The authors reflected on my comment regarding dam geometry and introduced a characteristic named “dam depth” (“dam height” may be more suitable). However, it is not appropriate to consider that dam height is identical to maximum breach depth. The worst moraine dam breaches reported in the literature are up to several tens of meters deep, however, the authors consider > 100 m for most of the lakes, resulting in the overestimation of what is called the worst case scenario. Here I use the example of Lower Barun lake to illustrate why:

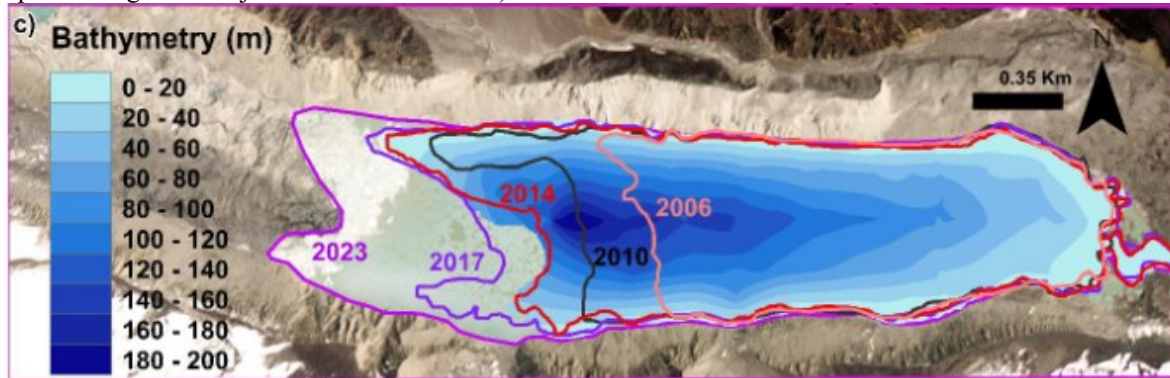
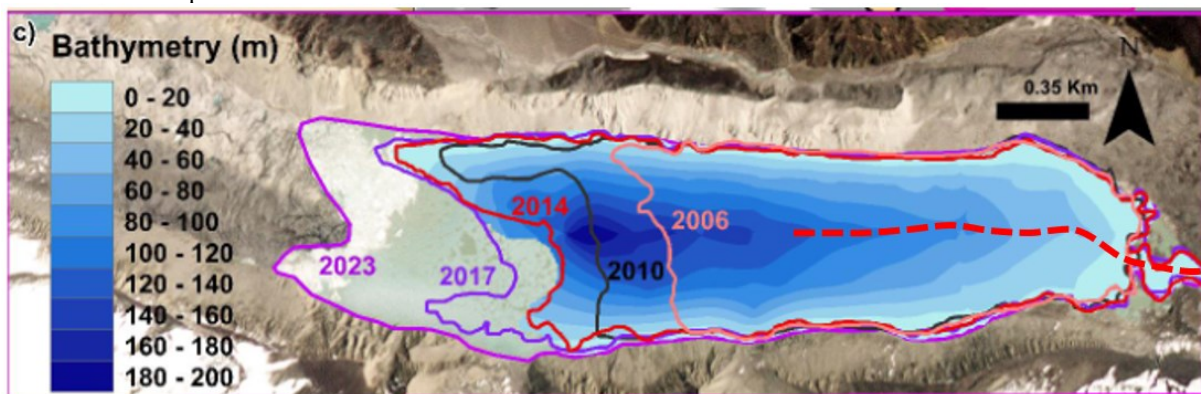
The authors estimated the dam height of this lake 128 m (from the toe to the crest) and consider this value the maximum breach depth. Now let’s have a look at the lake bathymetry from Gantayat et al. (2024; <https://doi.org/10.1016/j.scitotenv.2024.175028>):

I draw 128 m deep breach as dashed red line:

Such a breach (here I draw a profile) would have to be $> 2,500$ m long while its slope would have to be 0° at the same time (dashed red line):

Both these assumptions are unrealistic. In reality, the inclination of the breach channel will be $> 0^\circ$ (schematically represented by dashed green line). And this makes a huge difference. Further, since the lake occupies overdeepened depression, it is unlikely that the dam is even erodible to such depth (bedrock is likely at certain depth or the erosion would stop because of too low slope inclination of the channel).
